Littelfuse, Inc.
8755 West Higgins Road, Suite 500
Chicago, IL 60631 USA
(773) 628-1000

LFPCNIGBT2023-002

Change of Inner-Box Packing Label for IGNITION IGBTs

Date of Change: May 1, 2023

Appendix A: Before and after change of packing label on inner-box.

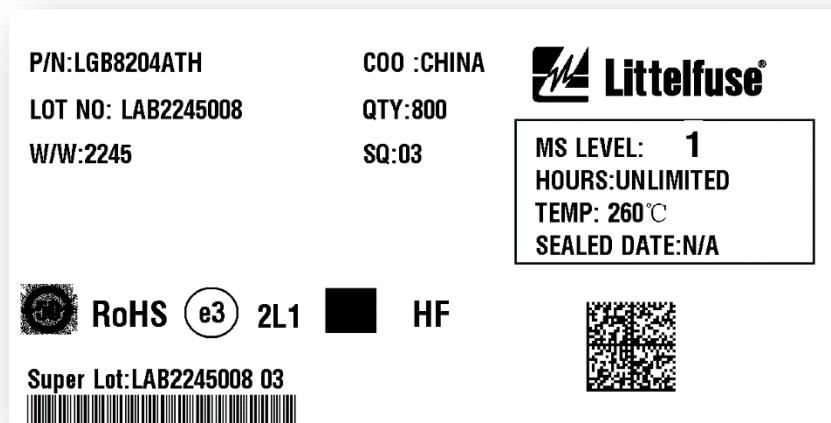
Littelfuse would like to notify the change of inner-box packing label of IGNITION IGBTs as shown in Appendix A. There is an addition of barcode for part number, quantity, lot number and date code on inner-box packing. The reason for the change is to enhance better traceability in logistics. No change in form, fit, function or performance of IGBT.

Appendix A: Before and after change of packing label on inner-box

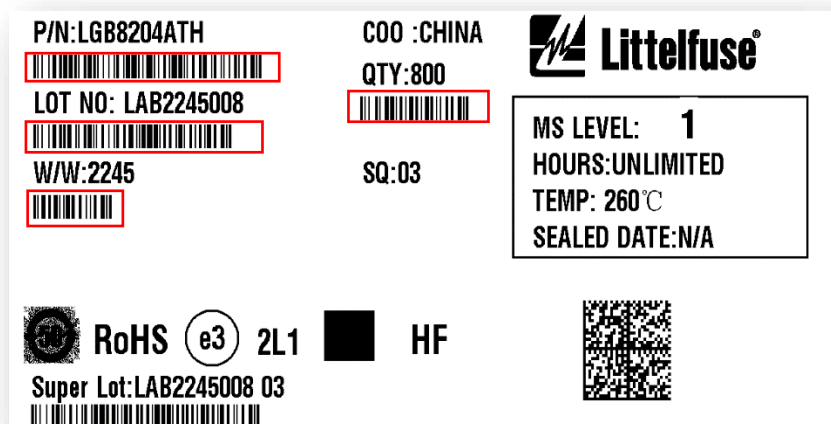
Changes: Addition of barcode for part number, quantity, lot number and date code on inner-box packing label
